**Date:** 11/20/2020  
**Project:** University of New Mexico Hospitals - New Hospital Tower  
2211 Lomas Blvd NE  
Albuquerque, NM 87106

**Bid Package:** Phase I - Make Ready  
**ASI #:** 04 (REVISED)

CG103

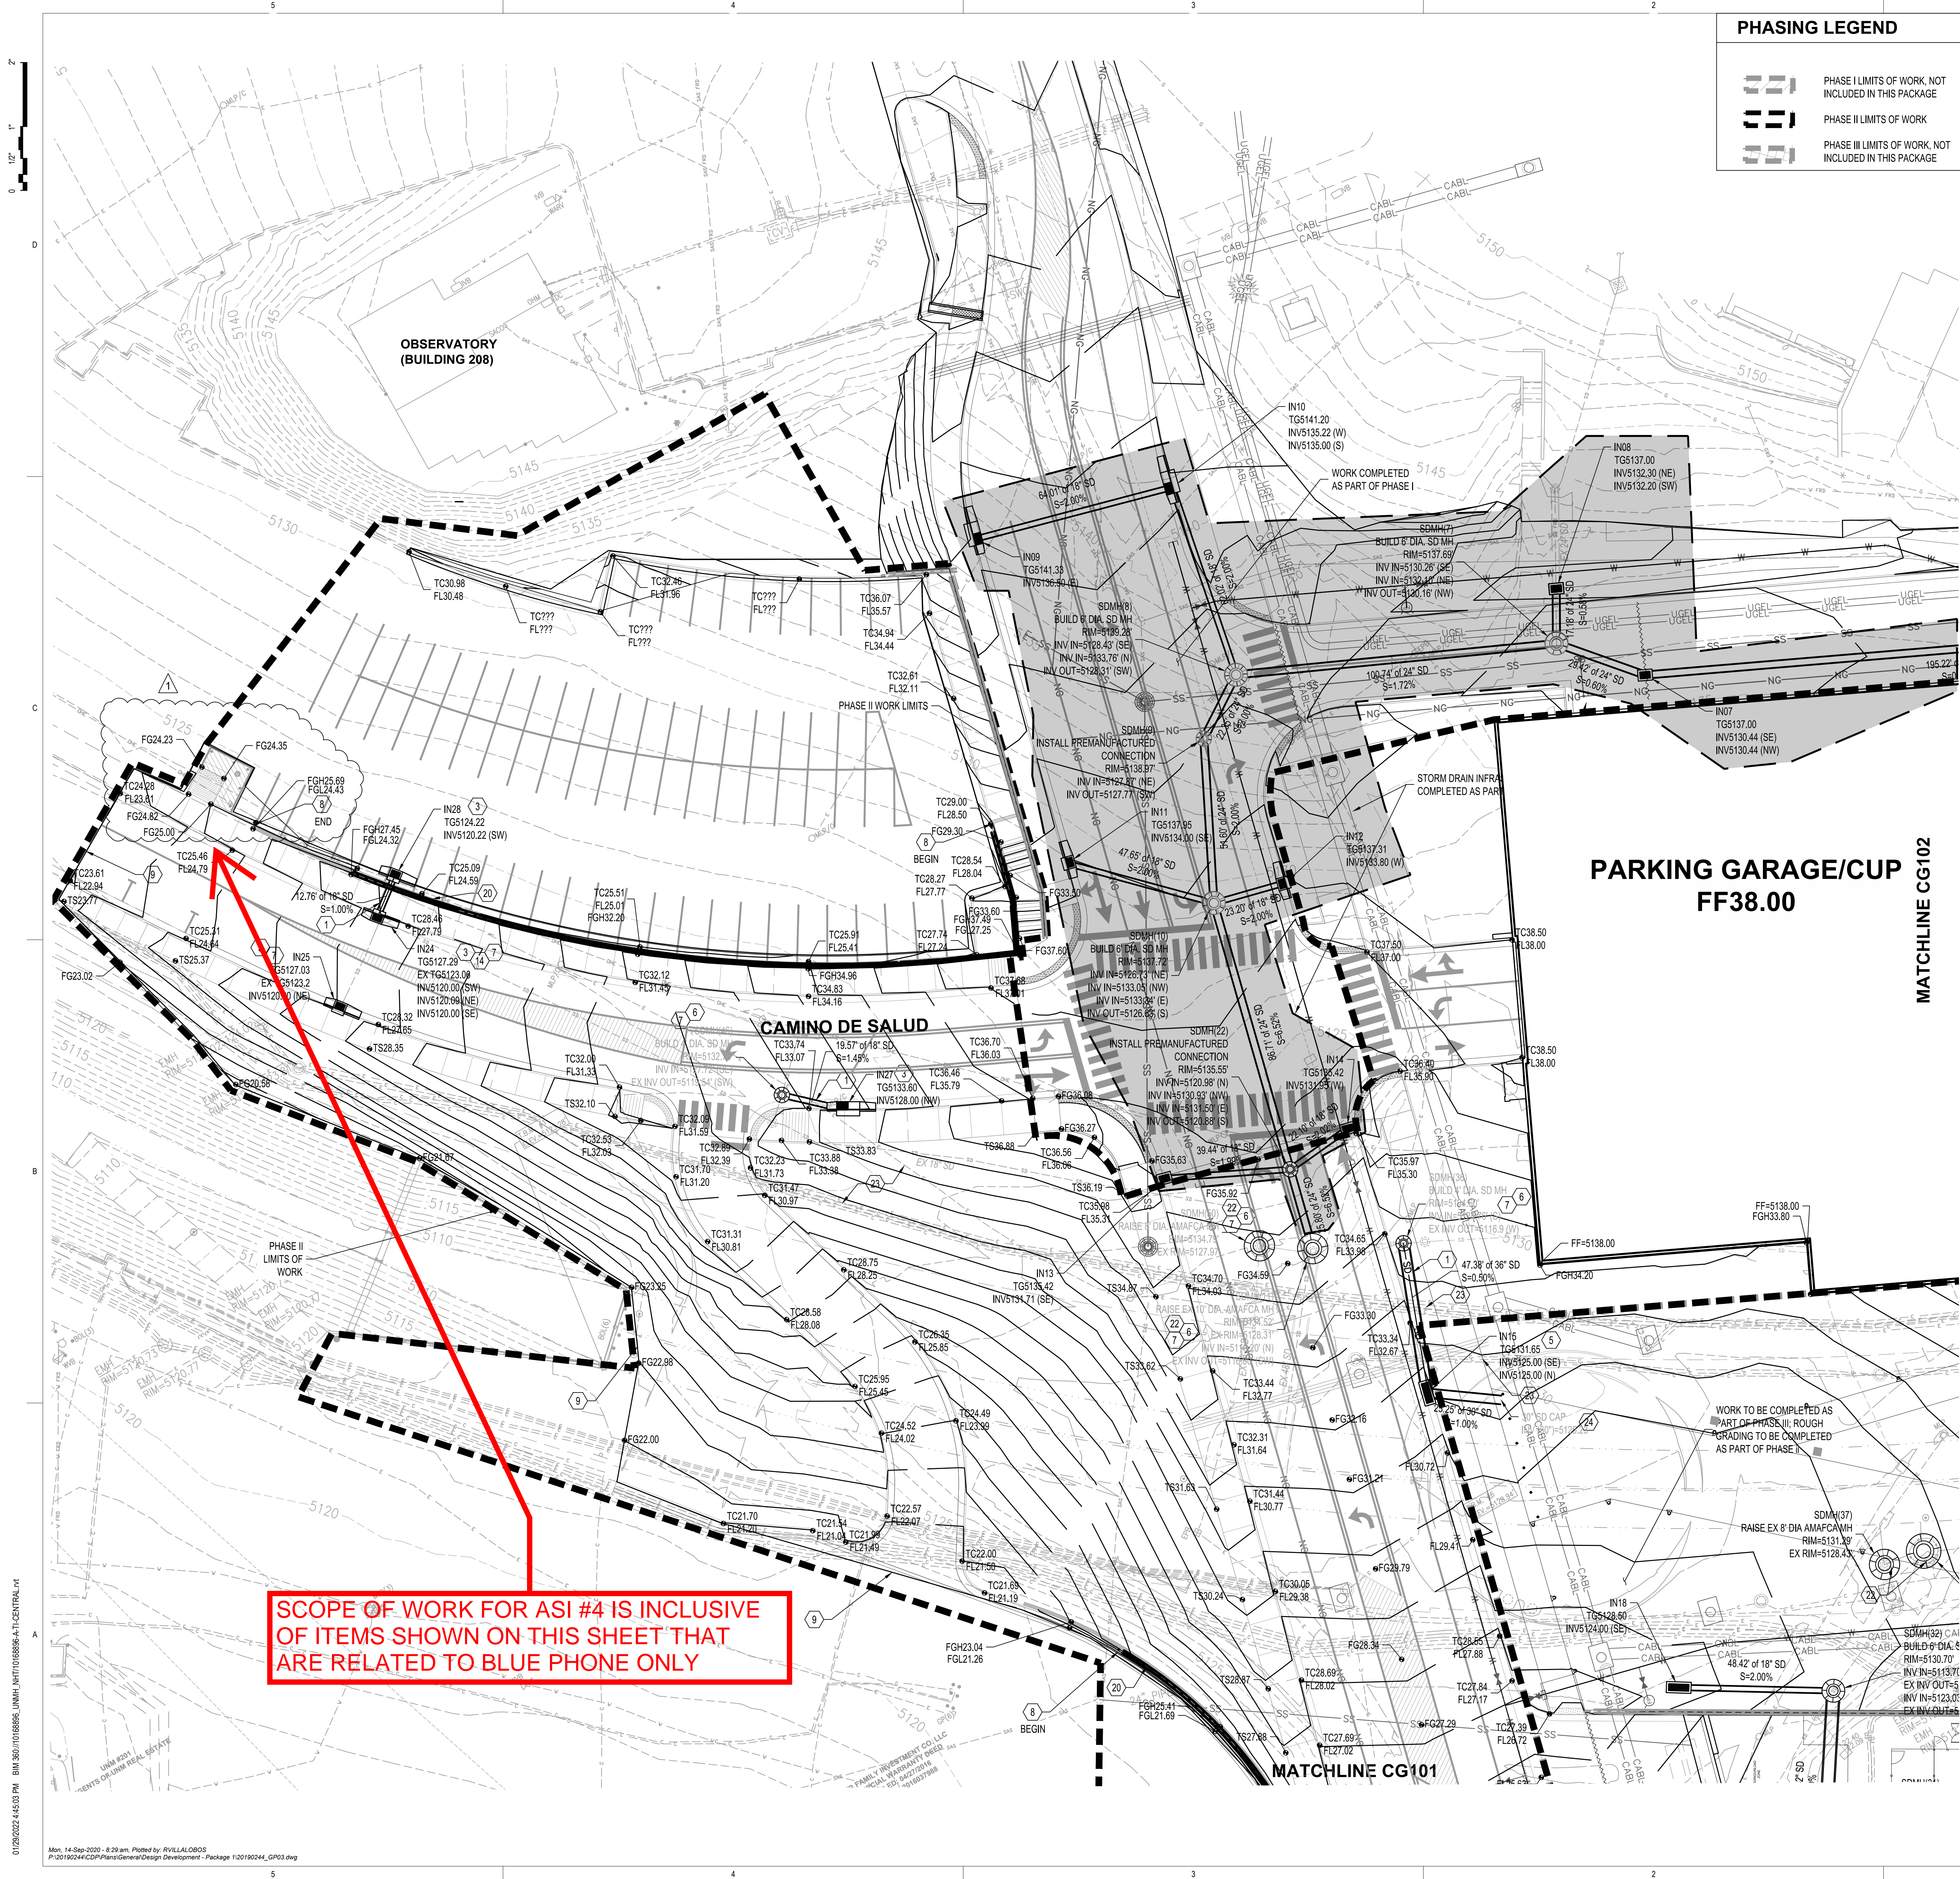
No	Doc Ref	Revision description
<b>Civil</b>		
1	CG103	Revised grading around the Blue Phone area. See revised sheet.
2	HC-103	Revised Horizontal Control around the Blue Phone area. See revised sheet.
3	N/A	CAD FILES WILL BE PROVIDED UNDER SEPARATE COVER TO BE USED FOR LOCATING BLUE PHONE.
<b>Landscape</b>		
1	LS102	Revised plan sheet showing updated south code blue phone location.
<b>Electrical</b>		
1	ES-100 (REVISED)	Revised plan sheet showing updated south code blue phone location.
<b>Technology</b>		
1	TS-100 (REVISED)	Add blue phone re-location requirements, conduit and cable. Refer to drawing for addition information.

SCOPE OF WORK FOR ASI #4 IS INCLUSIVE OF ITEMS SHOWN ON THIS SHEET THAT ARE RELATED TO BLUE PHONE ONLY

Sheet Number  
TS100

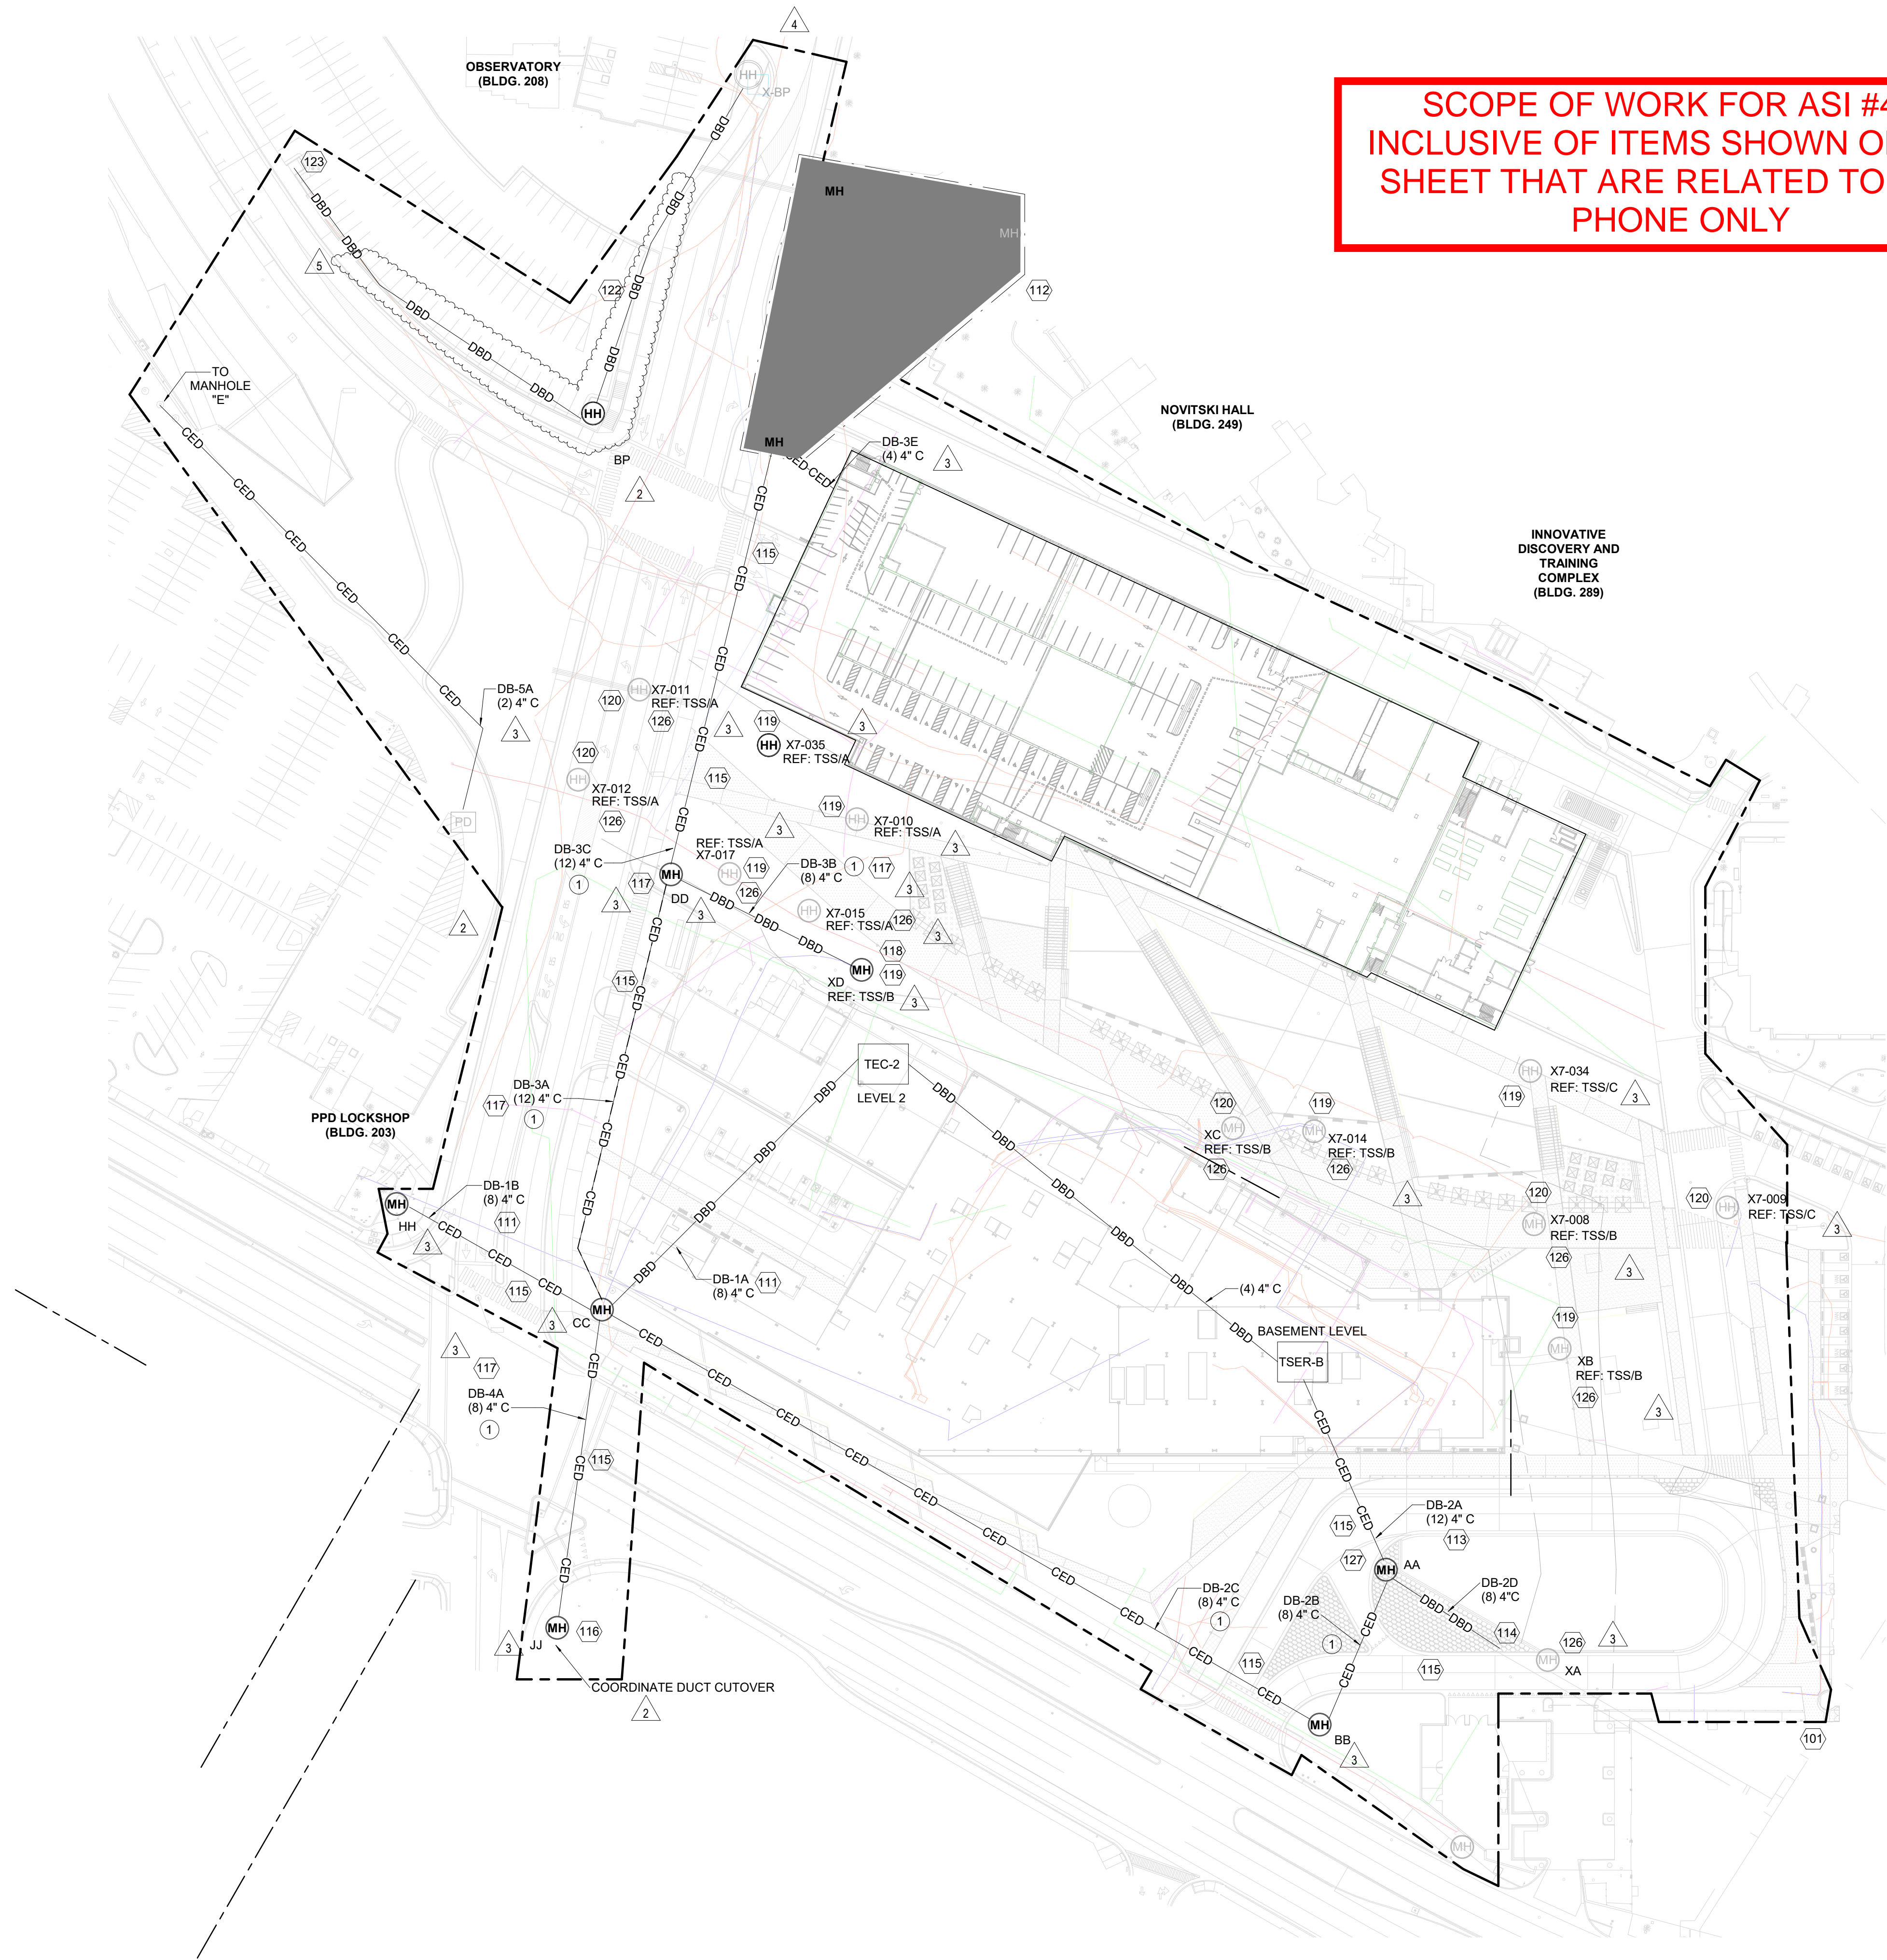
SCOPE OF WORK FOR ASI #4 IS  
INCLUSIVE OF ITEMS SHOWN ON THIS  
SHEET THAT ARE RELATED TO BLUE  
PHONE ONLY

- BLUE PHONE RELOCATION PATHWAY: INTERCEPT EXISTING COMMUNICATION CONDUITS STRUBBED TO THE NORTH END OF THIS PARKING LOT IN PHASE I. NEW CONDUITS SHALL MATCH EXISTING (SIZE AND TYPE). PROVIDE CABLEING SIMILAR TO EXISTING AND EXTEND NEW CABLEING TO BLUE PHONE LOCATION. SLICE CABLE IN ACCORDANCE WITH SPECIFICATION WITHIN EXISTING HANDHOLE DEVICE.

- BLUE PHONE LOCATIONS: NEW LOCATION OF EXISTING BLUE PHONE (DEMOTED) WITHIN PHASE I). COORDINATE CONDUIT PATHWAY ROUTING WITHIN BLUE PHONE BASE AND TERMINATE CONDUIT AND CABLE WITHIN BLUE PHONE DEVICE AS REQUIRED.
